KANATA NORTH URBAN
EXPANSION AREA

To / Destinataire	Wendy Tse	File/N° de fichier:
From / Expéditeur	Ted Cooper, P. Eng. Darlene Conway, P. Eng.	
Subject / Objet	Additional Comments: Kanata North Community Design Plan EMP and MSS Final Drafts (Novatech, April 4, 2016)	Date: May 10, 2016

**Reference: Kanata North CDP - EMP and MSS Final Drafts – Additional Comments
Response to Comments
Our File No. 112117**

POND 1 SECTION

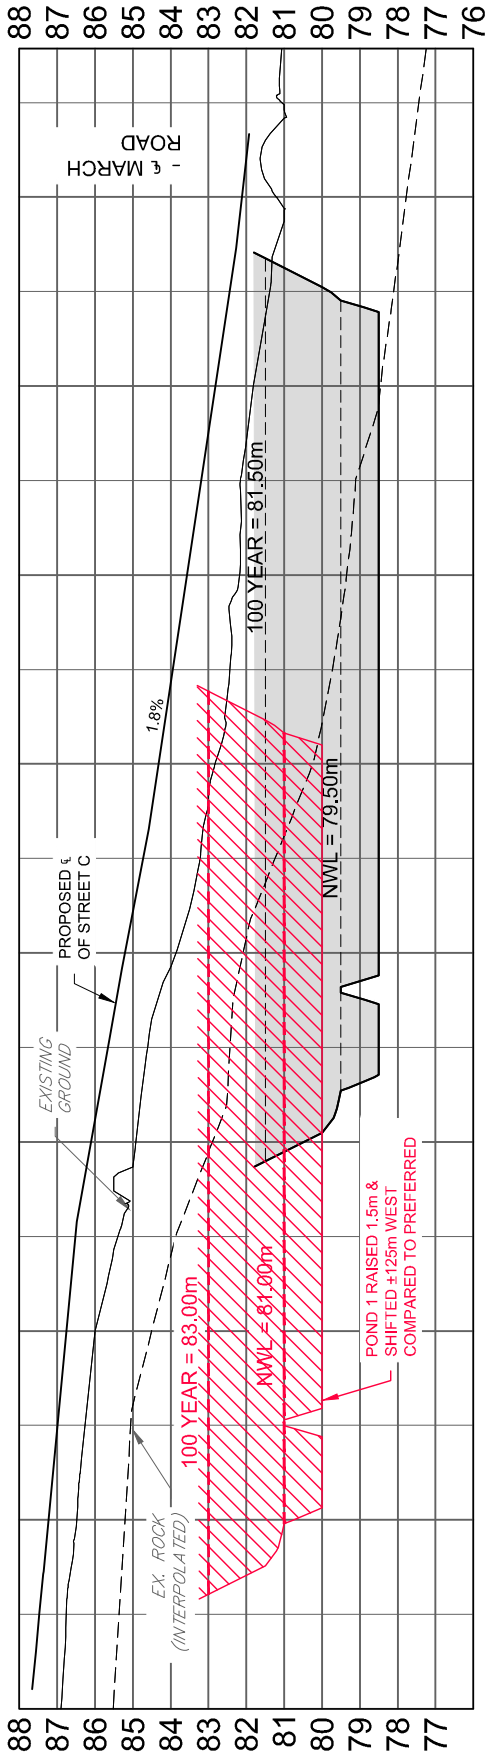
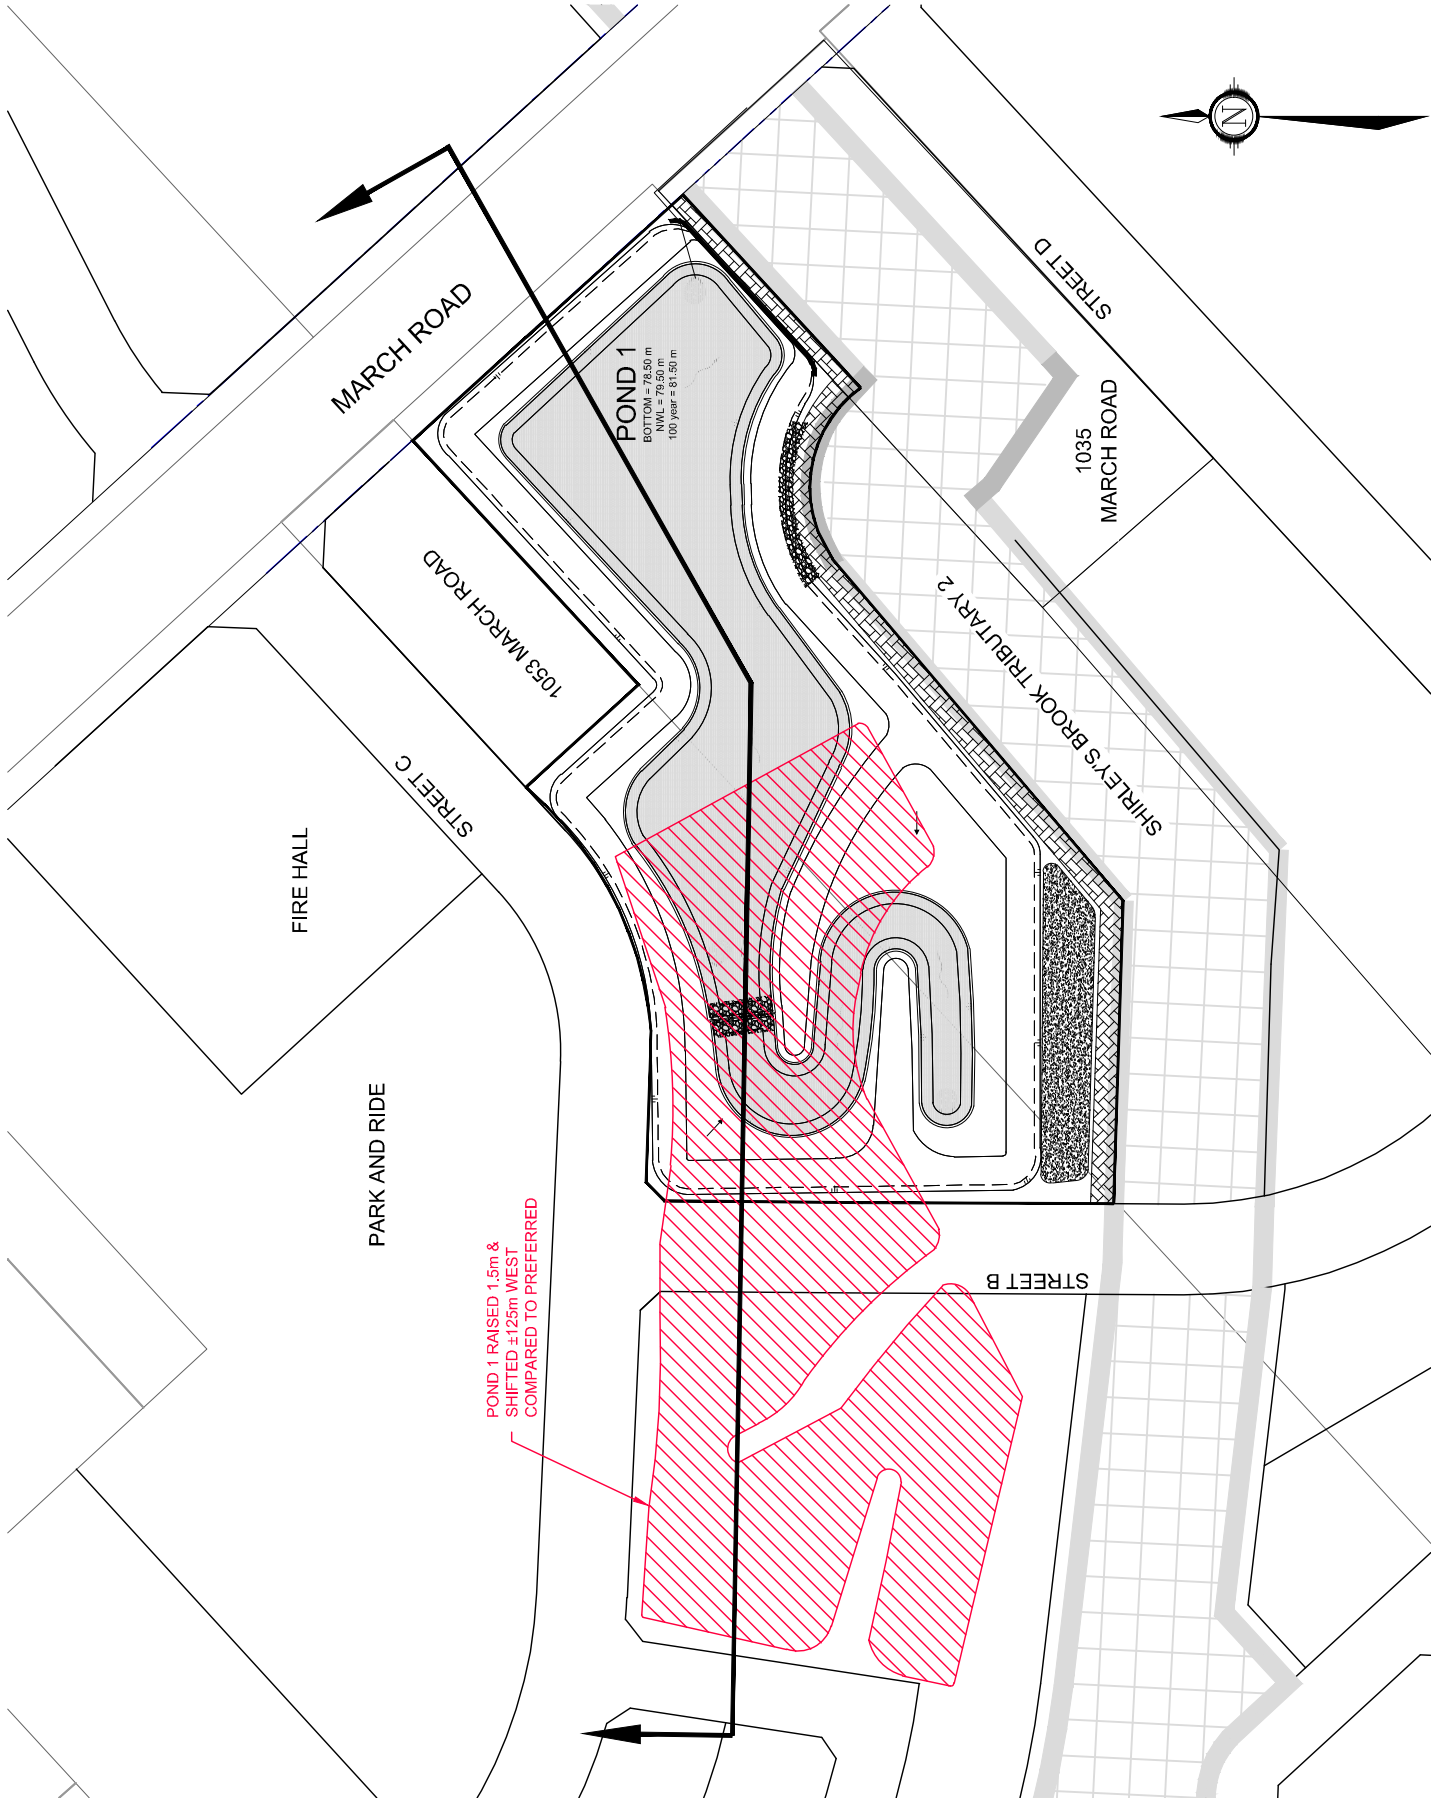
Based on information included in Appendix 2 of the MSS, the recommended storm servicing strategy will require 42,000 m³ of rock removal to construct Pond 1, and 7,500 m³ of rock removal to construct Pond 2. From a review of the MSS, it appears that much of the requirement for rock removal is created by the choice to construct 1800mm and 1350mm storm sewers **under** Tributaries 1 and 2, rather than to employ a conventional drainage strategy in which storm drainage is designed to follow the existing topography (rock removal volumes noted do not include the rock removal required to construct storm services below bedrock, just the ponds). Concerns were previously raised about these under-crossings in September 2015: “Why not drain southern portion of Pond 1 catchment to Pond 2 (and avoid undercrossing)?

Given the extent of rock removal, are there other alternatives available that can avoid the substantial rock removal requirements associated with the current MSS/EMP (i.e., by investigating the feasibility of expanding the capture area of SWM Pond 3 to include a portion of lands west of March Road, and if necessary, construction of temporary SWM controls until SWM Pond 3 is in operation?)

The above comments appear to be primarily focused on quantity of rock removal. It should be noted that the estimated rock quantities noted above have been taken from an earlier draft of the MSS (February 2016). The April 4, 2016 Draft MSS, as circulated for review, has lower estimated quantities of rock excavation (37,000m³ and 2,000m³ respectively for Ponds 1 and 2).

Consideration was given to minimize rock but as the site is located in Kanata, rock is close to the surface in many areas. The rock excavation required for the ponds is a direct function of the pond location (low points adjacent to tributaries) and size (based on drainage areas). During the detailed design, alternate servicing options and detailed pond grading could be considered to minimize rock excavation.

- The topography of the site is quite varied and the elevations climb rapidly west of March Road. As the rock elevation follows the ground surface, the amount of rock excavation would remain relatively the same, if not greater – **see attached sketches.**

Large discrepancies between Grading Plan and EMP at SWM Pond 1

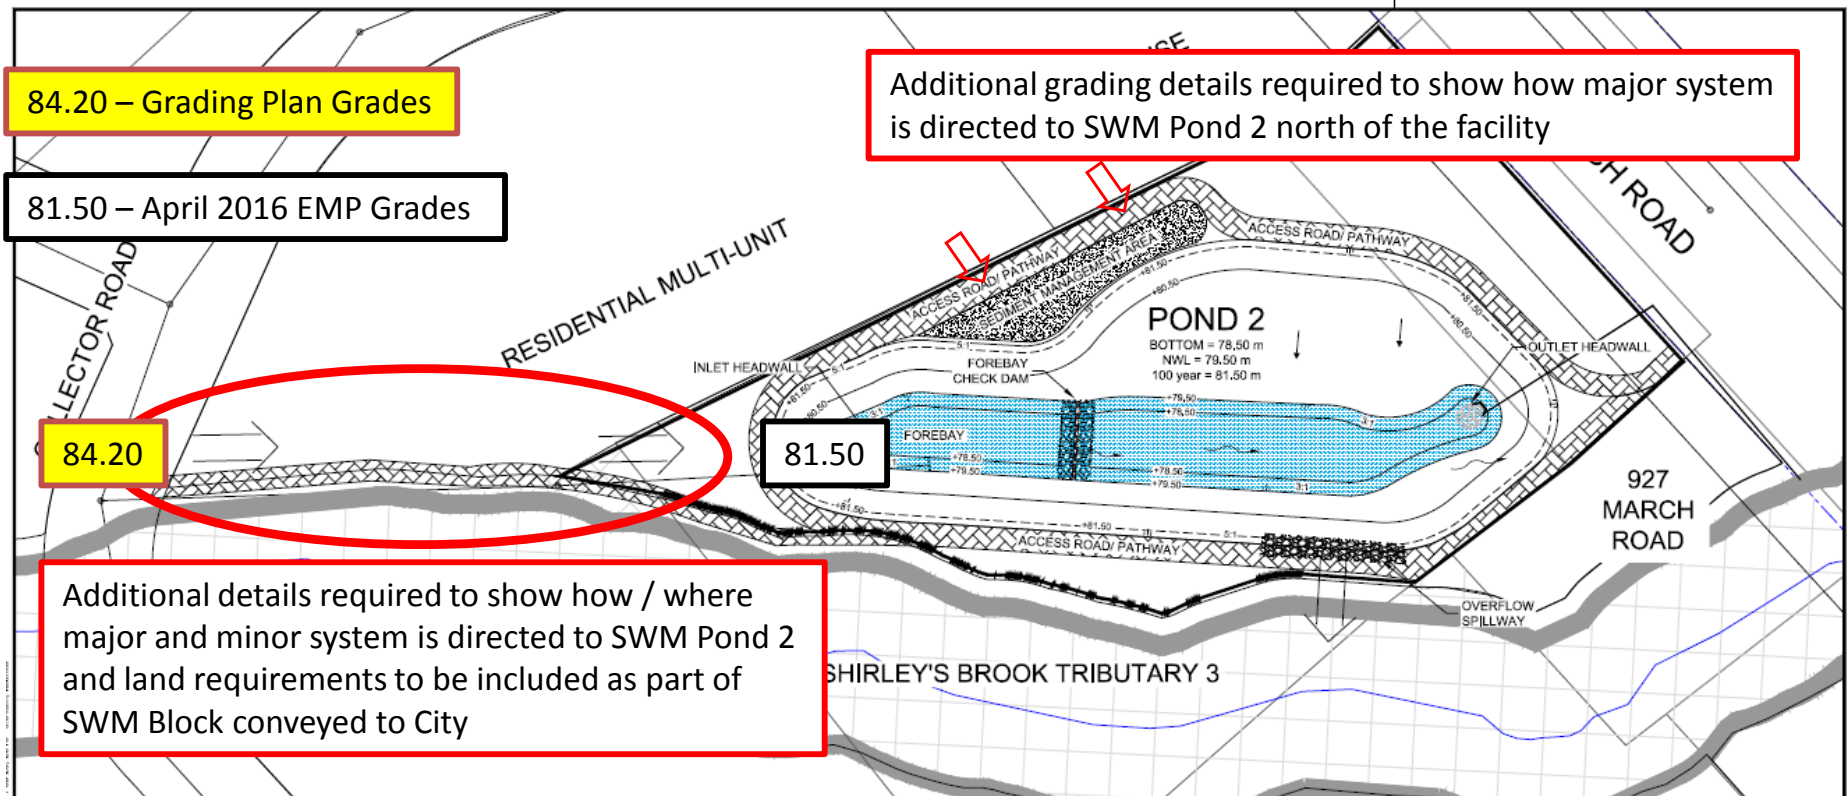
- The proposed grades at the perimeter of the pond are up to 5m higher than the grade identified in the SWM Block (e.g., 86.48m vs. 81.50m); subject to confirmation of the proposed grades, please note the City will not accept retaining walls within the pond block (or ROW);
- Given the comparatively steep road grade, please demonstrate how major system flows will be fully captured by SWM Pond 1 and not continue on to March Road;
- Maintenance access is required around the entire SWM pond – not just on lands abutting the Shirley's Brook tributary;
- Additional detail is required to demonstrate construction of SWM Pond 1 will not impact existing development at 1053 March Road.

Due to road grade, can major system flow be directed into Pond 1 – rather than be directed onto March Rd?

Require additional grading details to ensure compatibility with 1053 March Rd

When corrections are made to grades, make sure maintenance access is available to all areas of SWM facility

Additional grading details required to show how major system is directed to SWM Pond 2 north of the facility

Additional details required to show how / where major and minor system is directed to SWM Pond 2 and land requirements to be included as part of SWM Block conveyed to City

- The proposed grades shown on the conceptual design for Pond 1 have been revised to eliminate the retaining wall. The revised pond grading is shown on the updated Figure 9.1, which will be included with the Final EMP.

- The major system flow route has been updated to reflect the revised grading in the vicinity of Pond 1, and shown on the updated Figure 9.1. The majority of runoff from the upstream area would be directed into Pond 1 at a low point on Street C adjacent to the pond. Downstream of this low point, a small amount of overland flow from Street C will be directed onto March Road and into Pond 1, as indicated on the updated figure.

- Additional detail has been provided on Figure 9.1 to demonstrate no impact to the existing development at 1053 March Road.

- The overland flow route to Pond 2 will follow the proposed pathway/ access road adjacent to Tributary 3, as shown on revised Figure 9.2. The 6.0m wide pathway block will provide the required capacity to convey the overland flows from Street A to Pond 2 – supporting calculations will be provided in the MSS.

M:\2012\112117\CAD\Design\EMP\MEMO (KJA)\Figure 9.1 - Pond 1 Functional.dwg, Figure 9.1 - Pond 1, May 18, 2016 - 1:09pm, kbanks

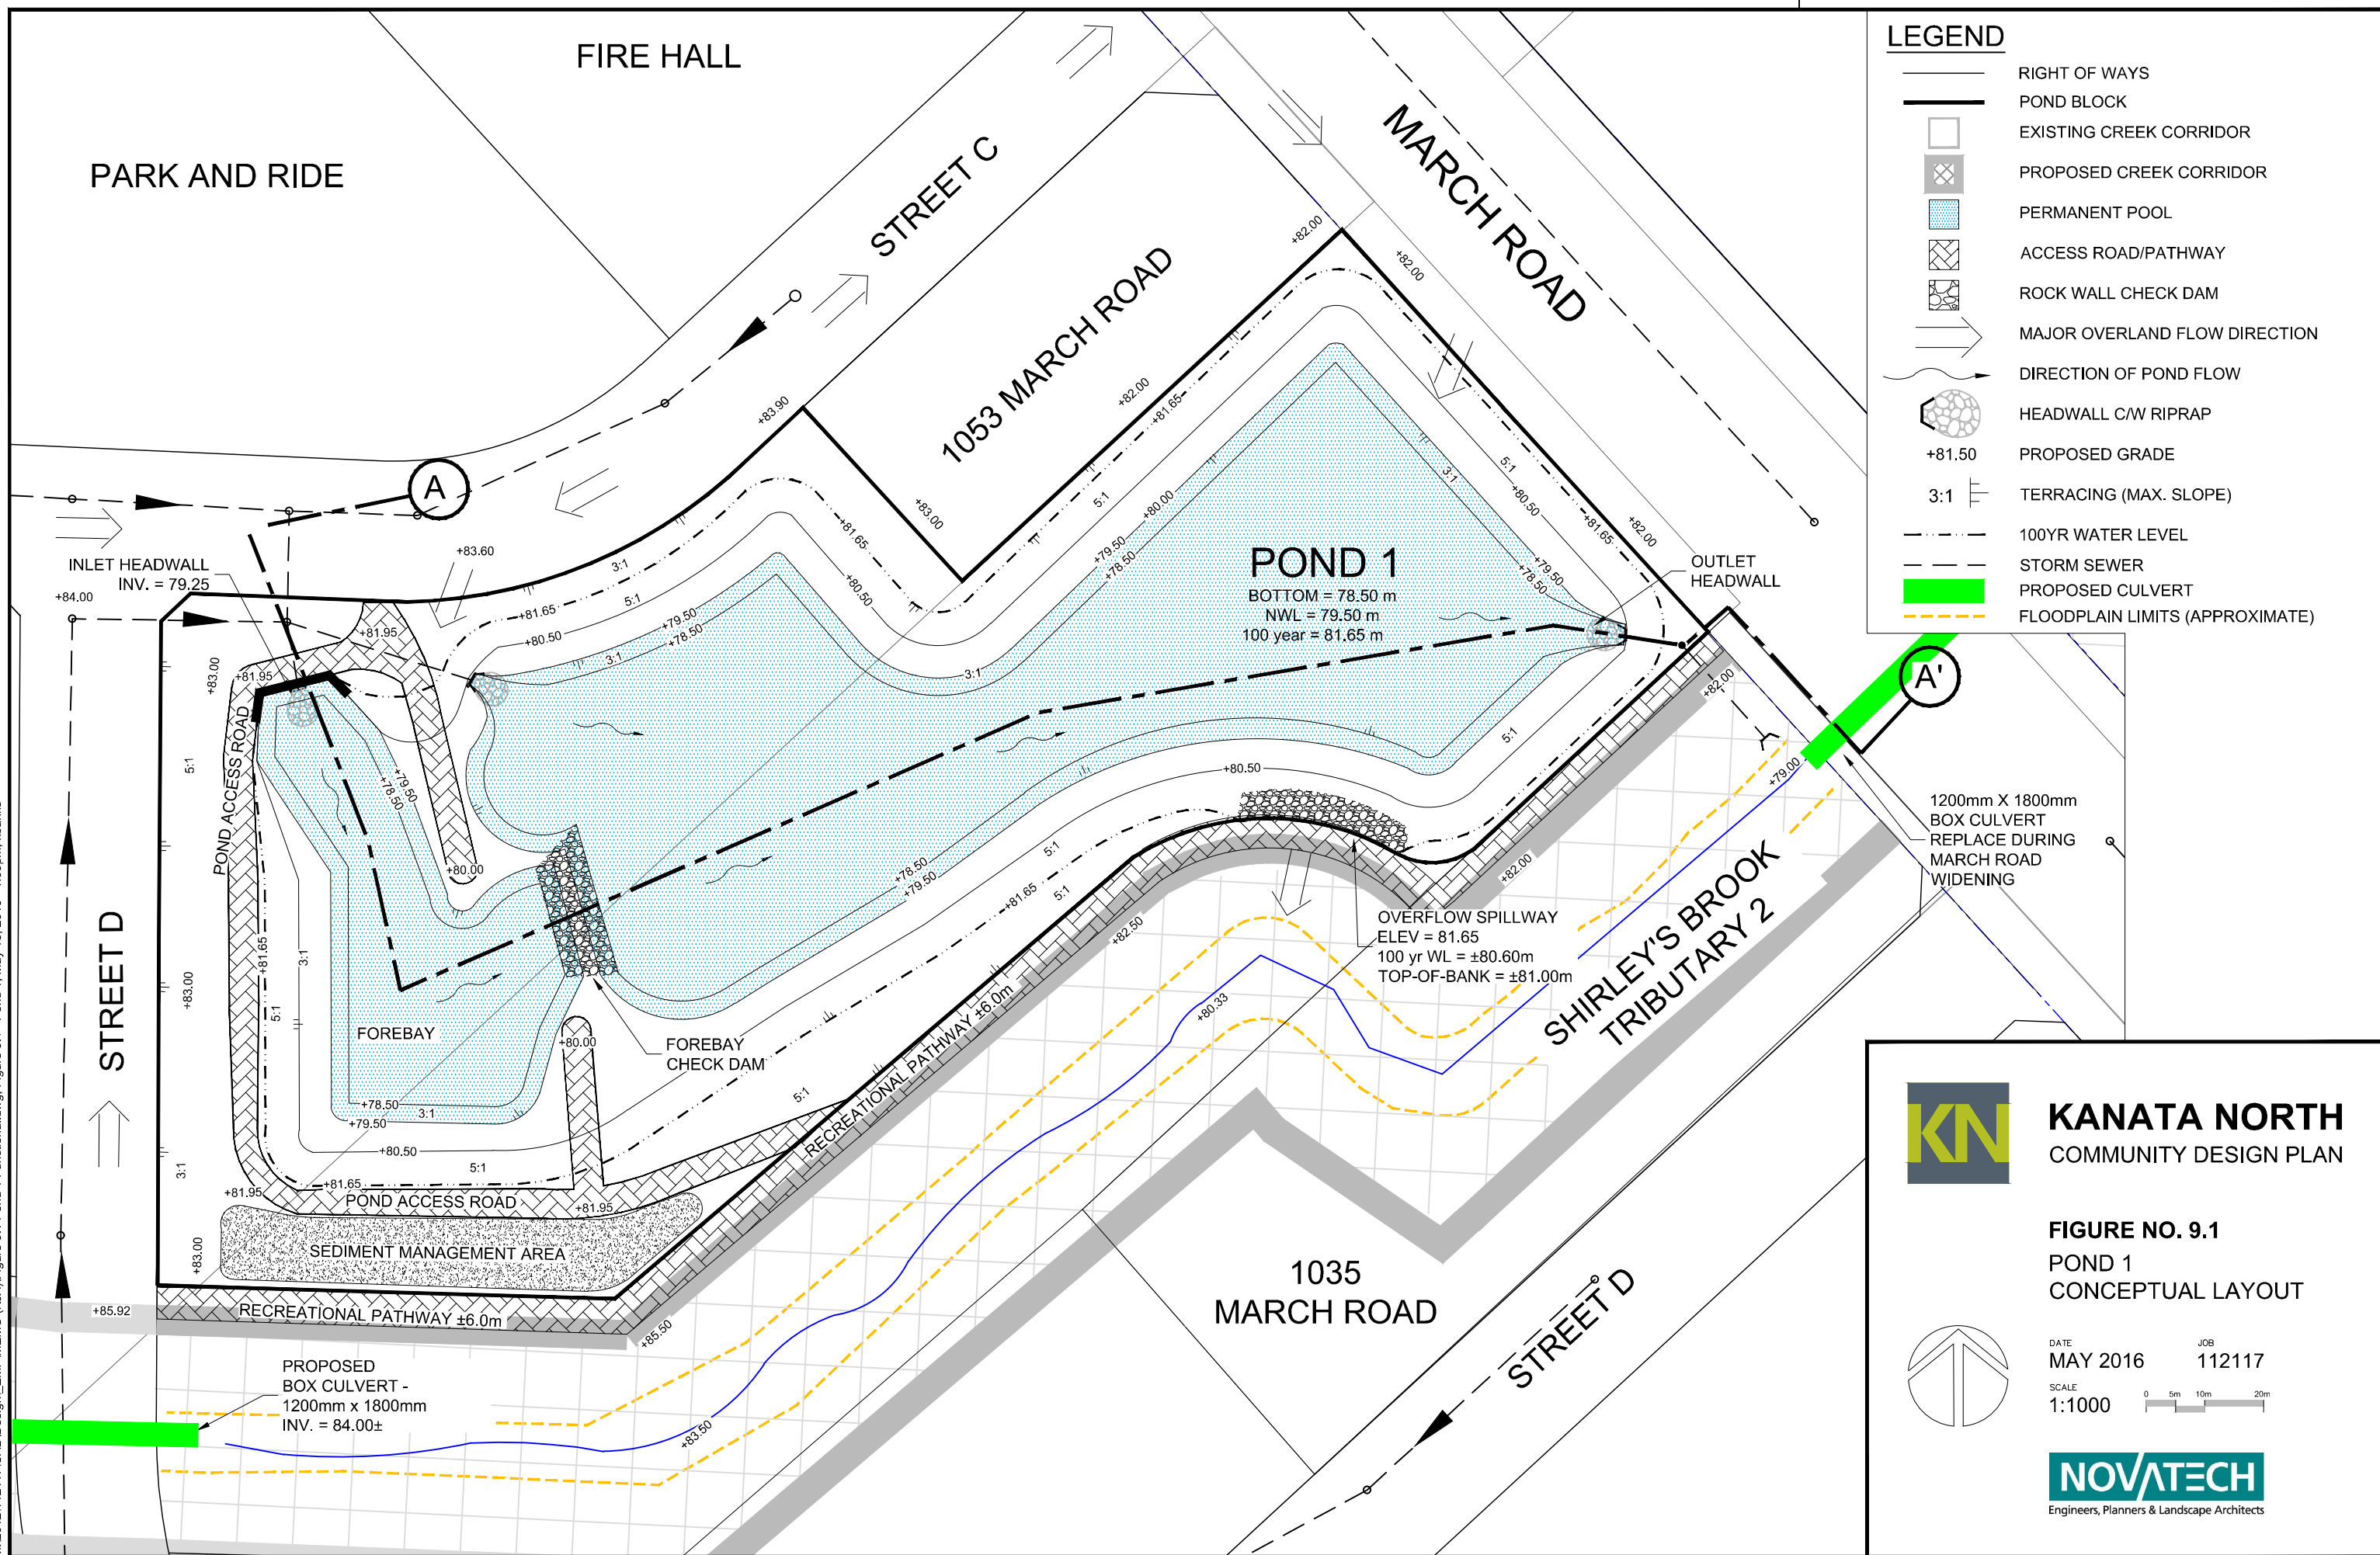
- a) The proposed grades at the perimeter of the pond are up to 5m higher than the grade identified in the SWM Block (e.g., 86.48m vs. 81.50m); subject to confirmation of the proposed grades, please note the City will not accept retaining walls within the pond block (or ROW);

- b) Given the comparatively steep road grade, please demonstrate how major system flows will be fully captured by SWM Pond 1 and not continue on to March Road;

- d) Additional detail is required to demonstrate construction of SWM Pond 1 will not impact existing development at 1053 March Road.
